DRUID'S GLEN ROAD – PHASE 3 - CHERRYWOOD SDZ

STAGE F (PART 1) ROAD SAFETY AUDIT

15 April 2025

2.1.1 Problem: Unsafe short cut to Lehaunstown Lane

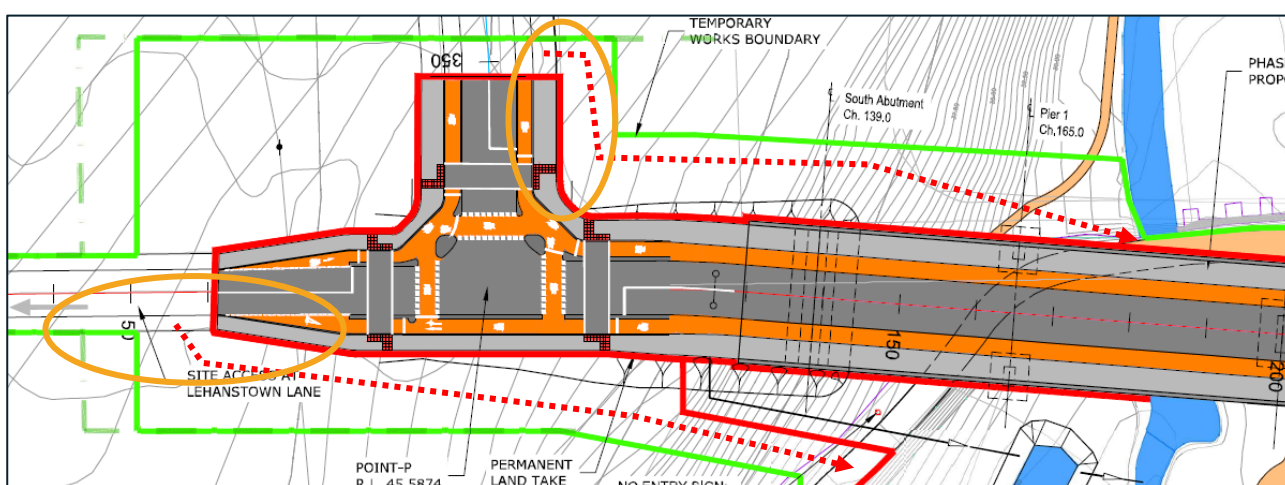
There does not appear be any fencing along the back of footpath to prevent a pedestrian taking a short cut along a natural desire line for access between the southern section of Druid's Glen Road and the proposed shared active travel path along the existing Lehaunstown Lane by walking on a steep embankment.

Hazard

A pedestrian could fall and injure themselves on the steep embankment on the southern side of the stream valley.

2.1.2 Problem: Safe regulated access provision to/from Lehaunstown Lane

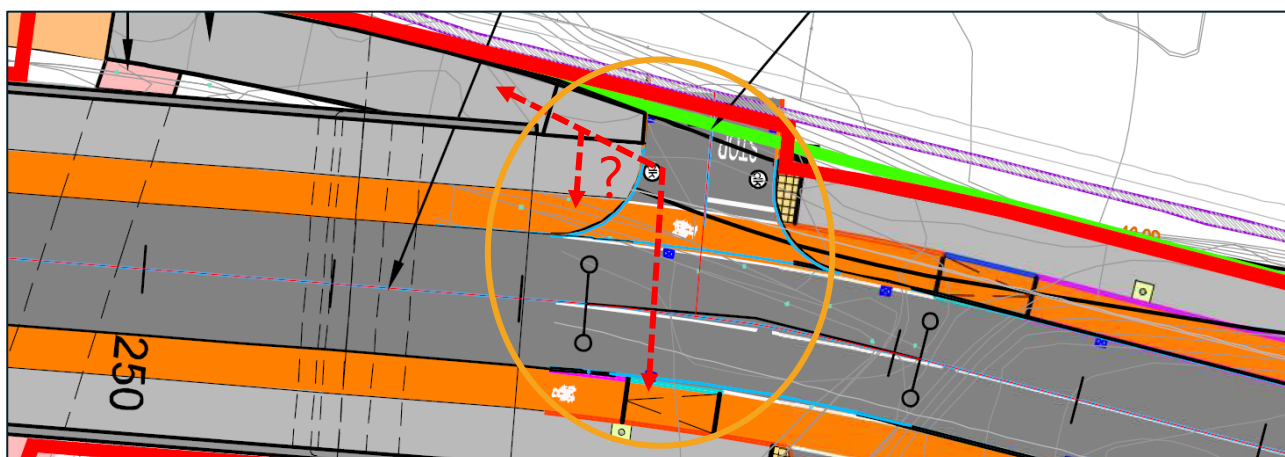
There is no regulated provision for cyclists to safely access the proposed shared active travel path along the existing Lehaunstown Lane from the upper level adjacent to the bridge and vice versa, along a natural desire line.

Hazard

A collision could occur between a cyclist and a passing vehicle at the bridges or a pedestrian on the footpath when trying to access or egress the proposed shared active travel path along the existing Lehaunstown Lane.

2.2.1 Problem: Exposed vertical ends of concrete barrier for Option 1

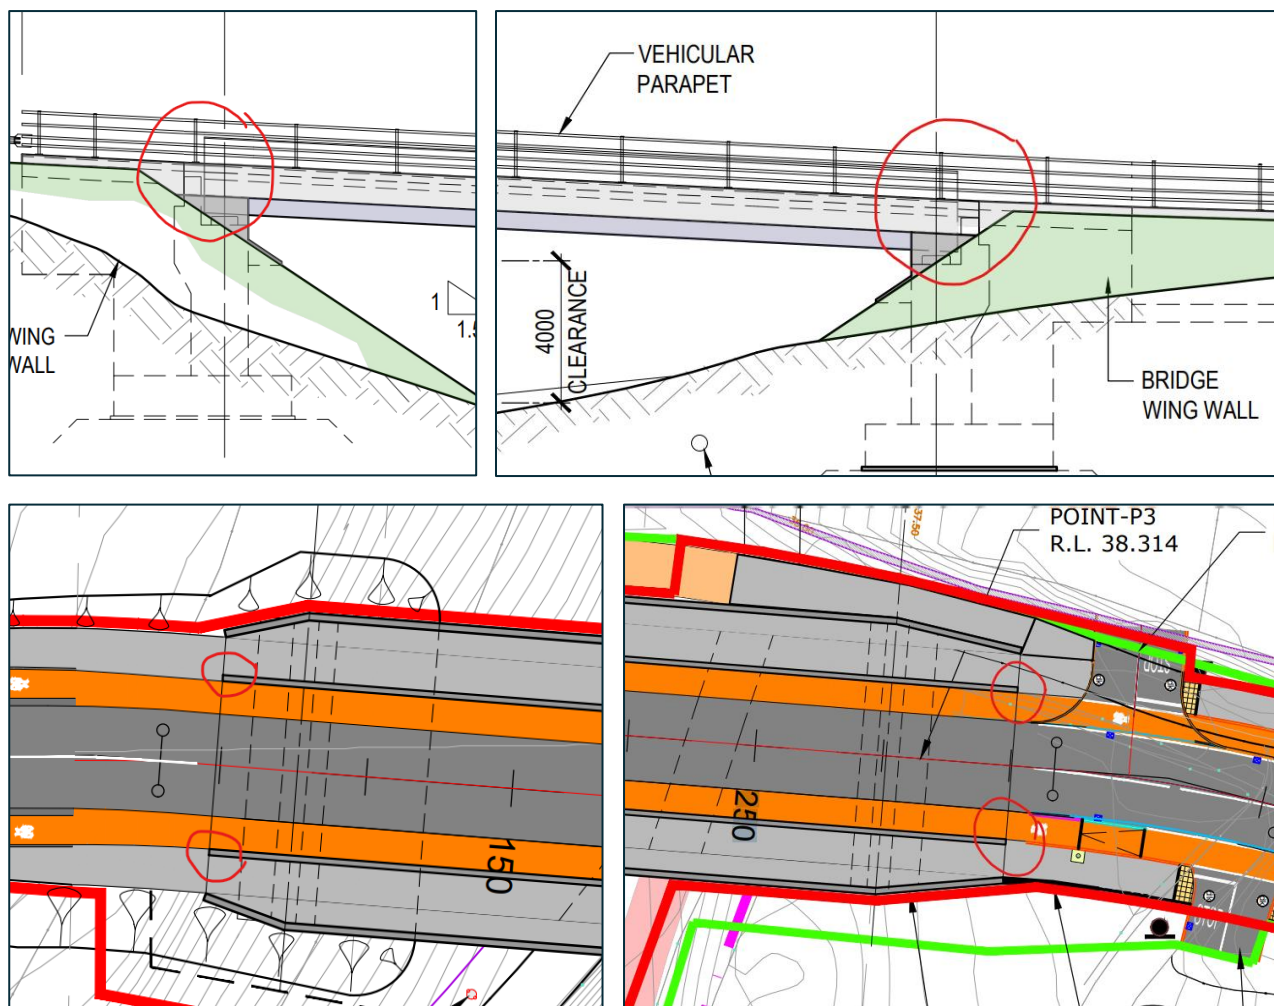
The ends of the proposed concrete barrier are indicated as terminating in a vertical face for Option 1.

Hazard

The vertical barrier ends represent a hazard to cyclists and motorists.

2.2.2 Problem: Cycle track alongside vertical feature for Option 1

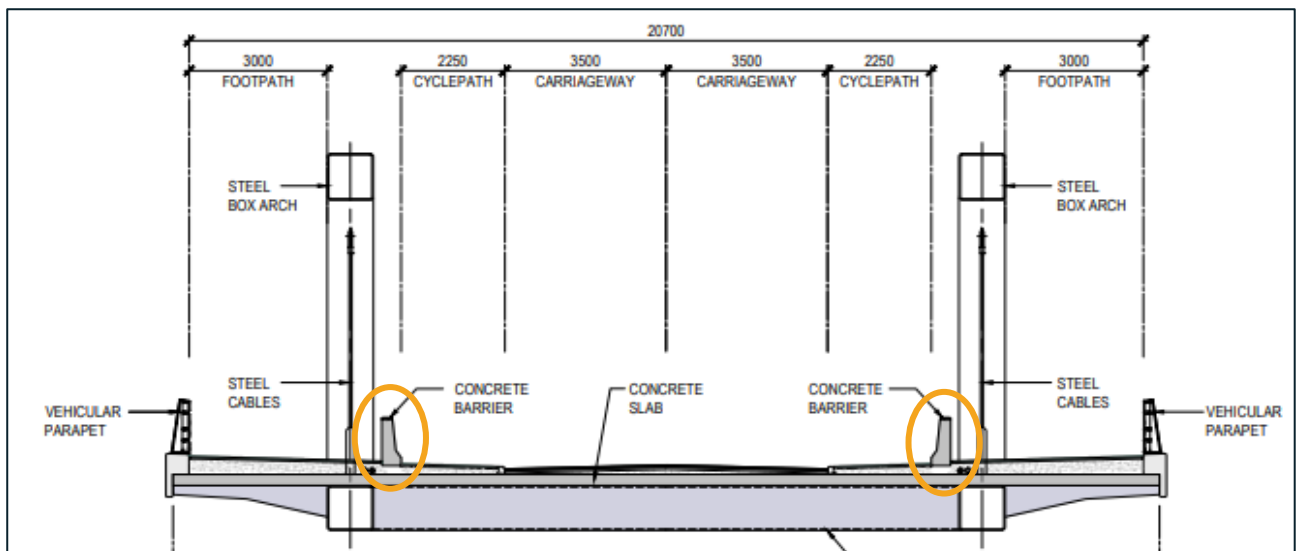
The width of the cycle track does not allow for additional inside clearance where it runs alongside the adjacent concrete vertical barrier for Option 1. Furthermore, there is no proposed surface feature at the inside edge of the cycle track that would facilitate a safe redirection of a bicycle front wheel away from the concrete vertical barrier.

Hazard

A cyclist's handlebar or pedal could strike the concrete barrier leading to them falling off their bike.
